DRAFT Documents Farley 4b

1. Summary Description

Joseph M. Farley Nuclear Plant

**License Amendment Request to Revise Technical Specifications to
Implement NEI 06-09, Revision 0, "Risk Informed Technical Specifications
Initiative 4b, Risk Managed Technical Specifications (RMTS) Guidelines"**

Bases Insert 1

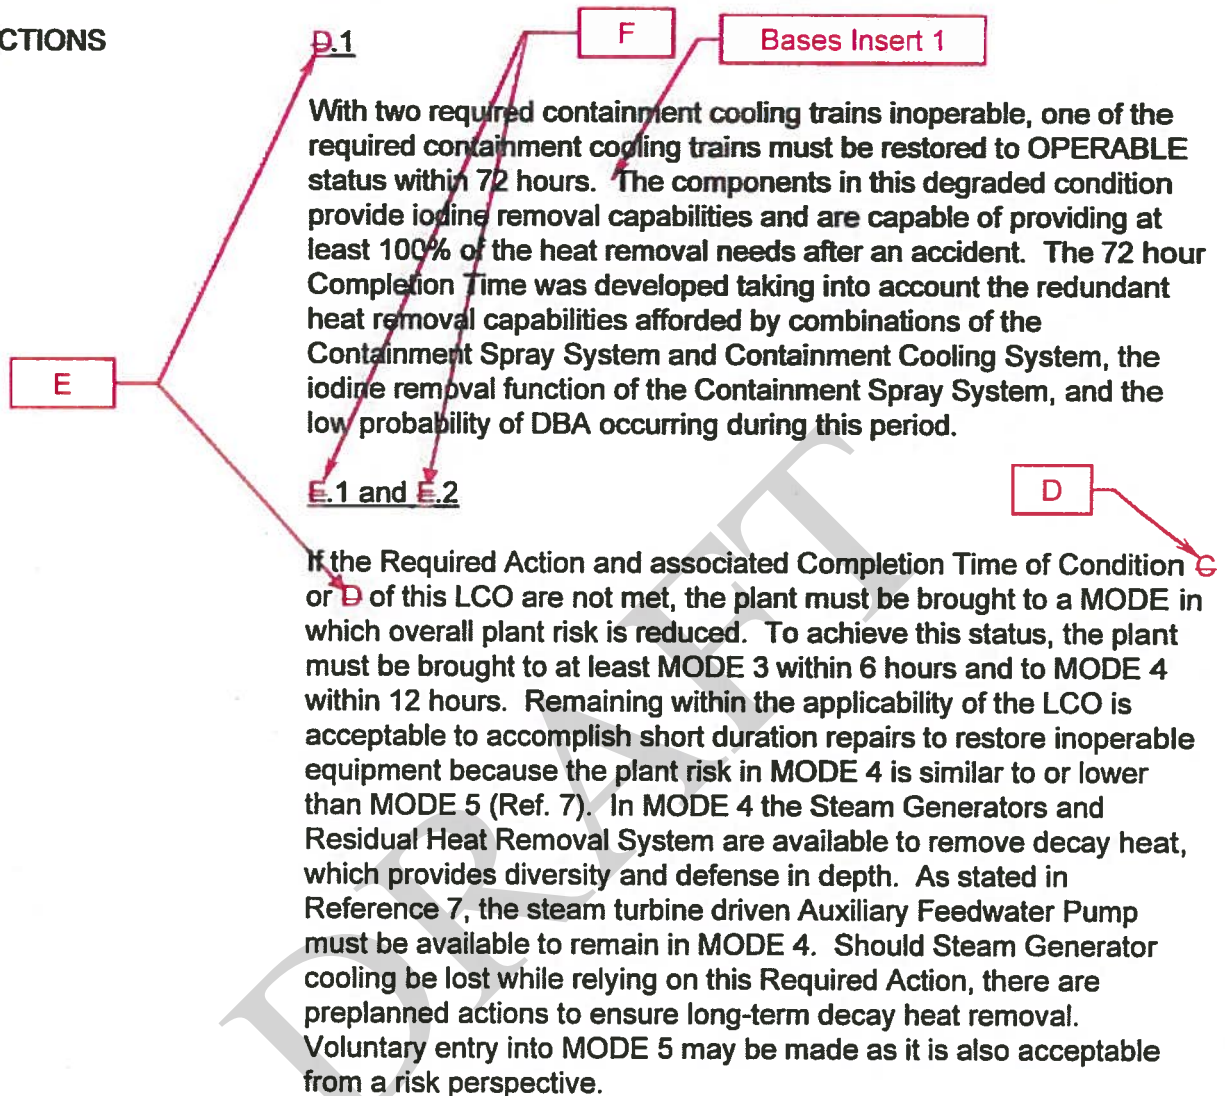
With one of the required containment cooling trains inoperable, the inoperable required containment cooling train must be restored to OPERABLE status within 7 days. The components in this degraded condition provide iodine removal capabilities and are capable of providing at least 100% of the heat removal needs. The 7 day Completion Time was developed taking into account the redundant heat removal capabilities afforded by combinations of the Containment Spray System and Containment Cooling System and the low probability of DBA occurring during this period.
